Cumberworth Lane, Denby Dale

Road Safety Audit

Stage 1

Designer Response

Appendix C – Visibility Splays

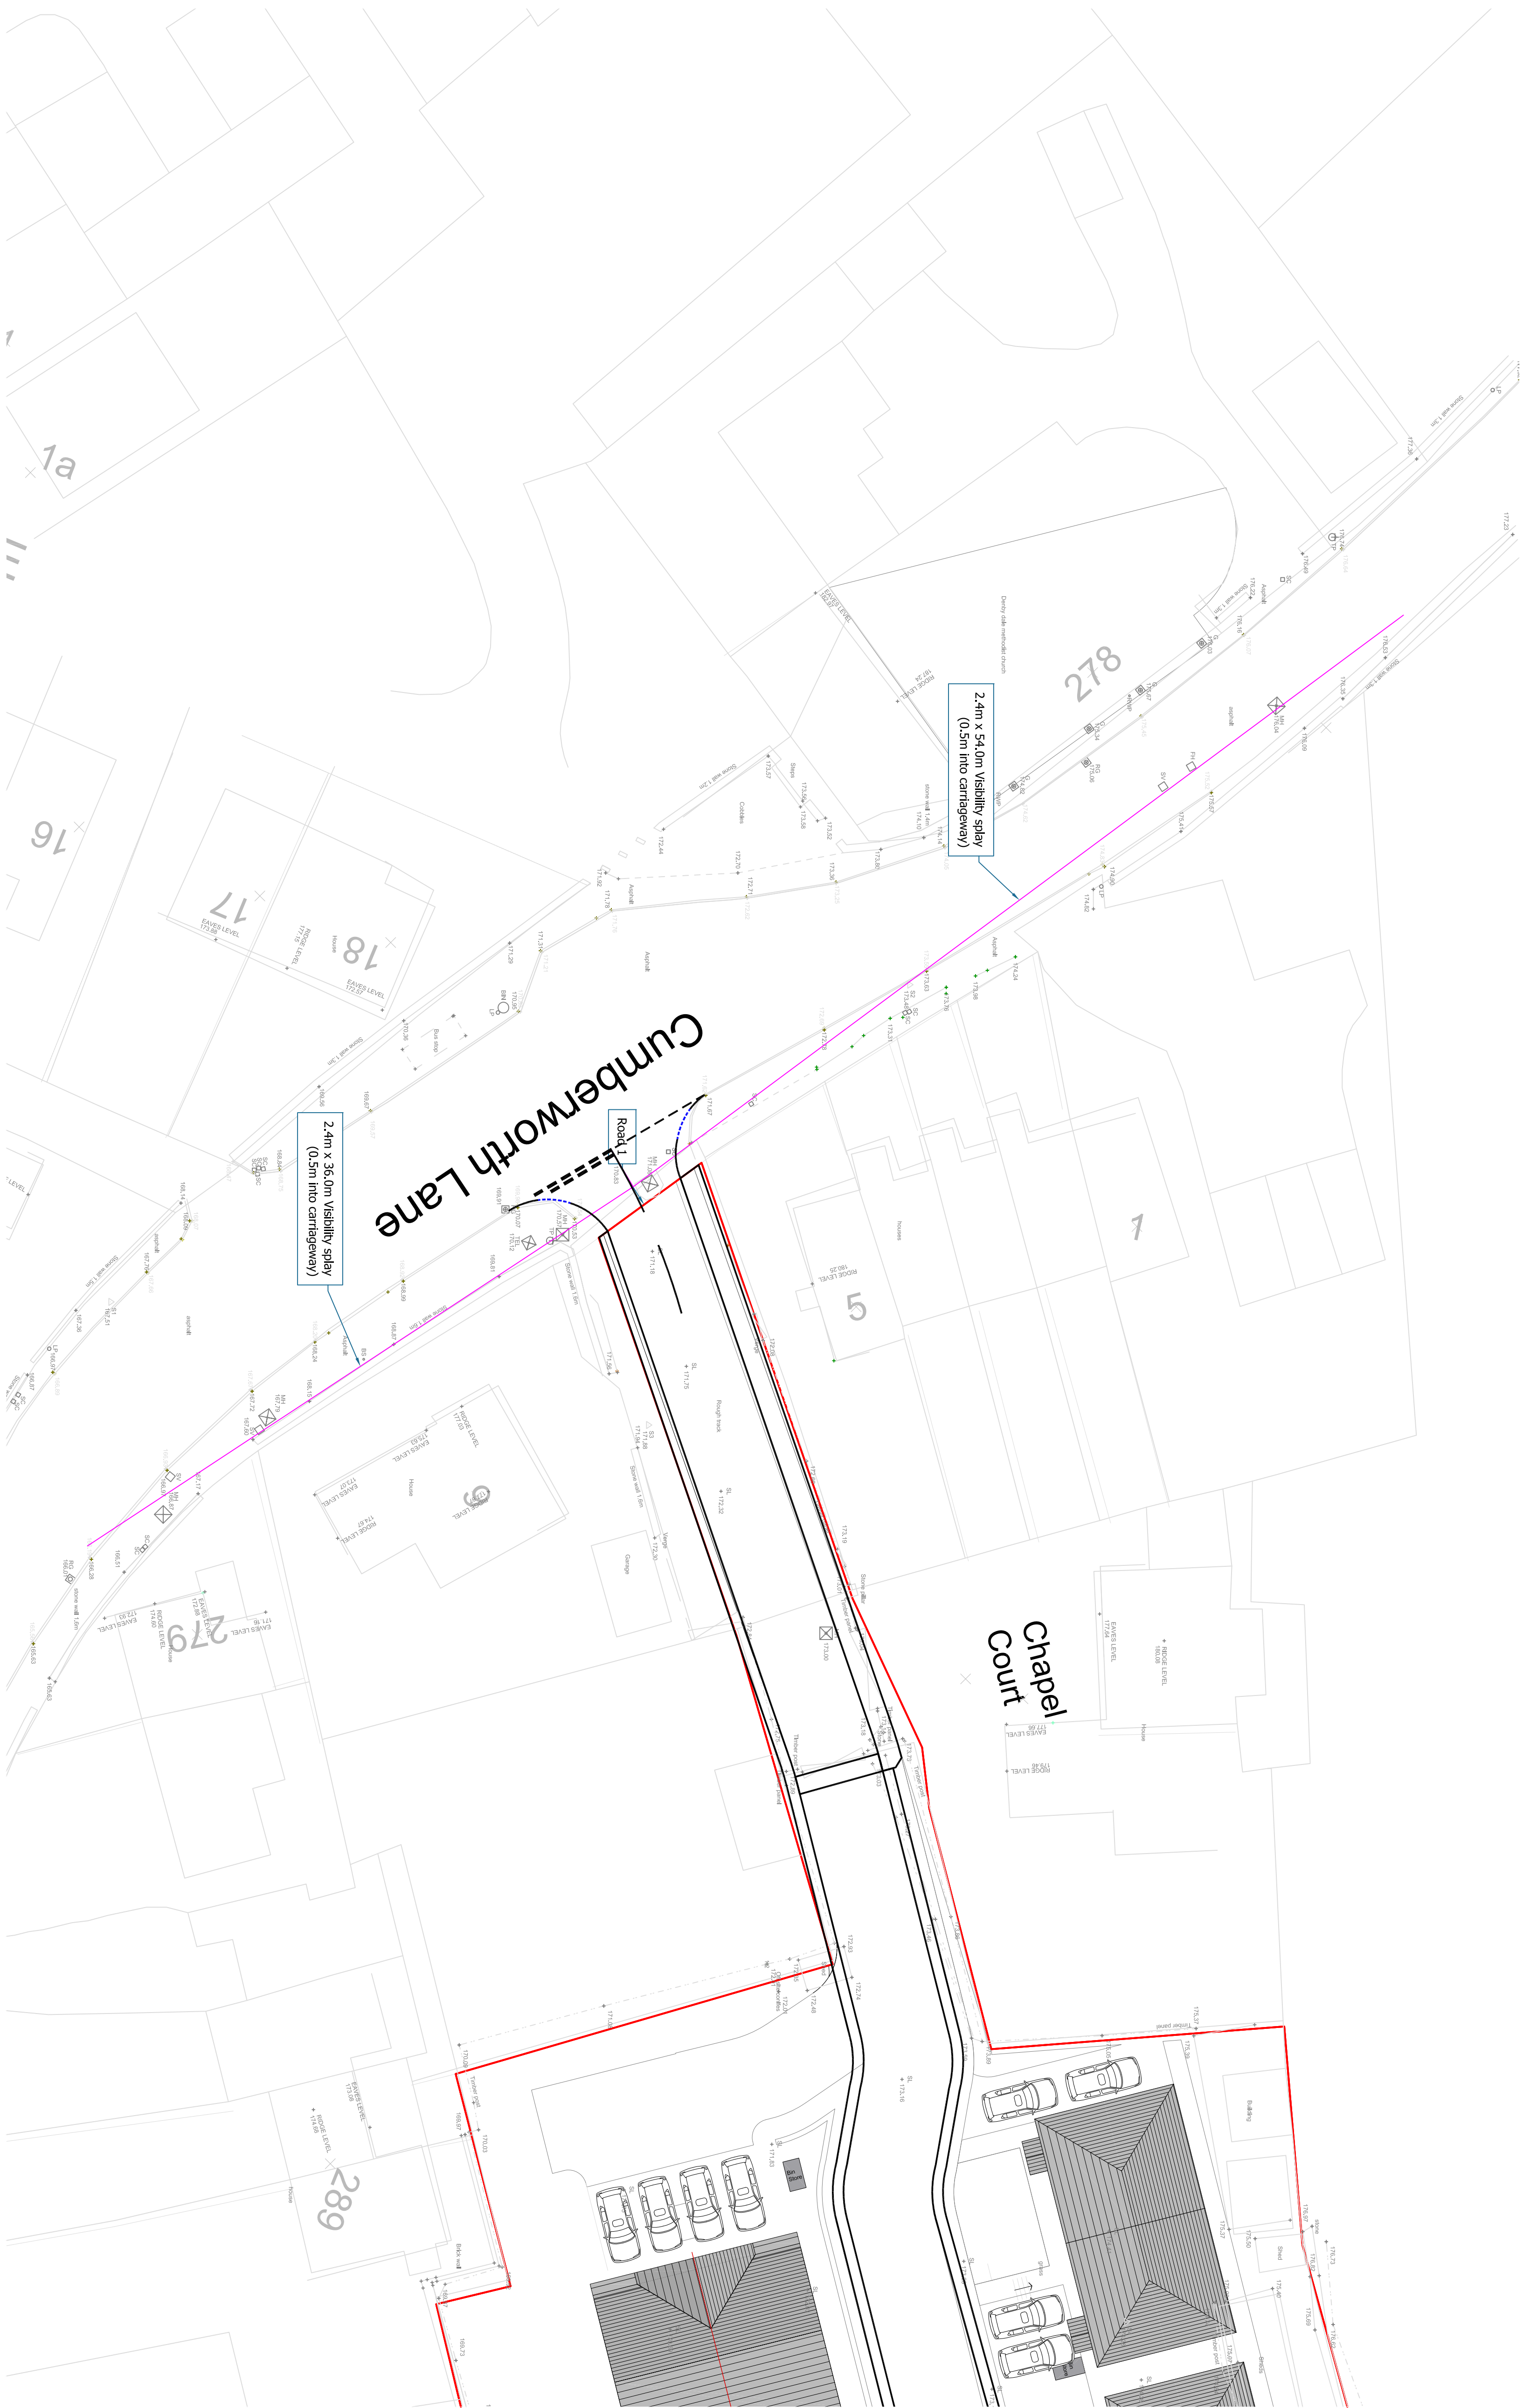
Detail: The proposals do not indicate what sightlines will be achieved at the new junction with Cumberworth Lane. It seems that they will be adequate however there is a bus stop and clearway on the south-east side of the new access road. Although this is existing, there will be more traffic using the access and the sightlines will be blocked when a bus is waiting.

Recommendation: Ensure that adequate sightlines can be achieved and that the existing bus stop and clearway do not create a problem for vehicles exiting the new development.

Design Team Response (1): The proposed sight lines have been added the latest submission as shown in Appendix C.
